## ADDENDUM # 1

**To: File 2006-150-49-5039**  
**IFB for: Purchase and Installation of Cabinets at Victoria Plaza Apartments**

# CABINETS AND COUNTERTOPS SOLICITATION FOR SAN ANTONIO HOUSING AUTHORITY VICTORIA PLAZA MODERNIZATION

Project number	16-084	<h2 style="margin: 0;">AM-00</h2>
Date	7/7/2020	
Drawn by	Author	
Checked by	Checker	
		Sheet <u>1</u> of 16

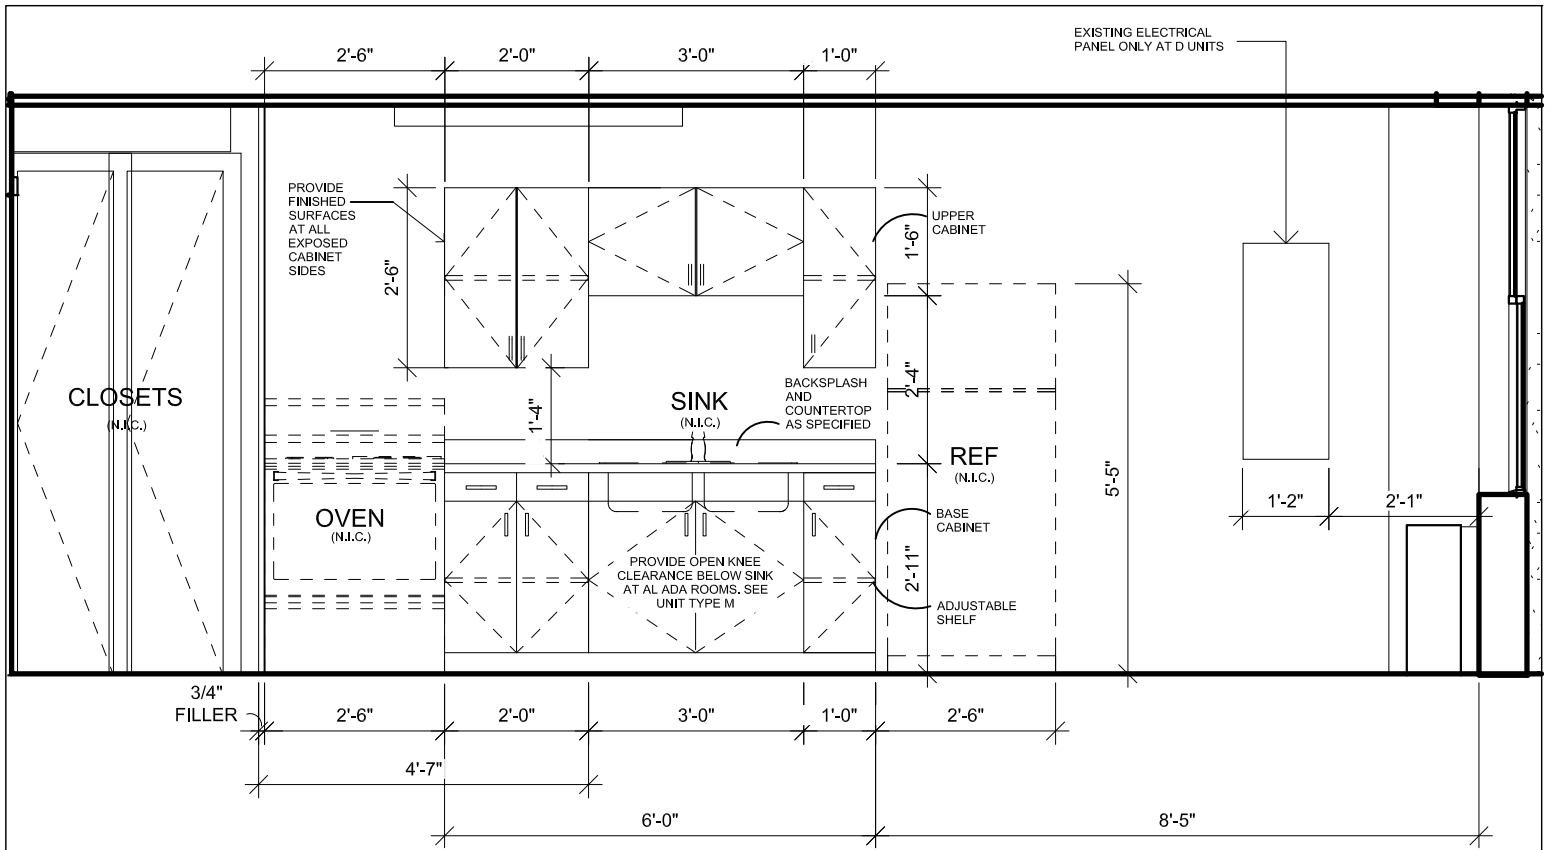
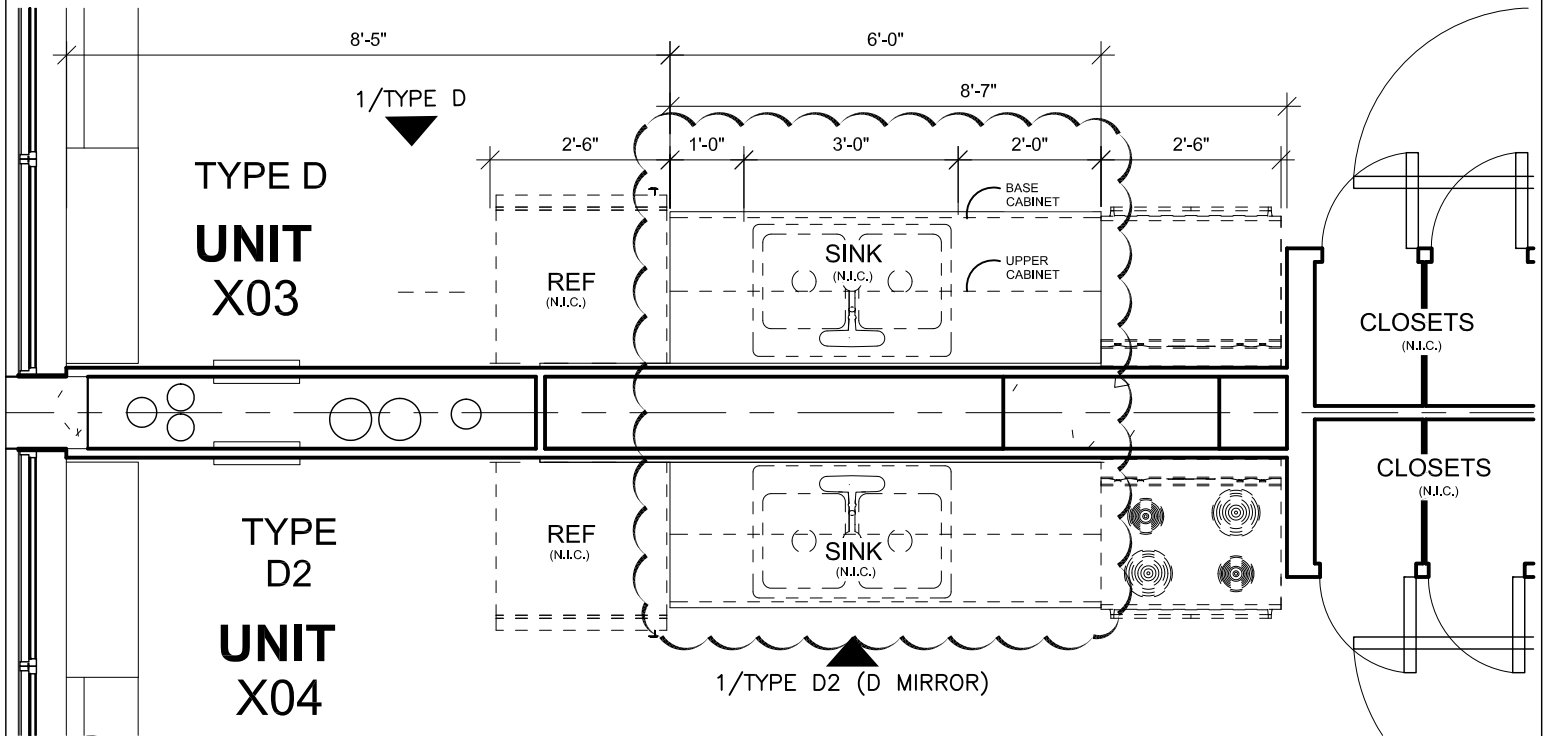
**Delete Pages AM-00 and AM-06 and replace with the attached revisions.**
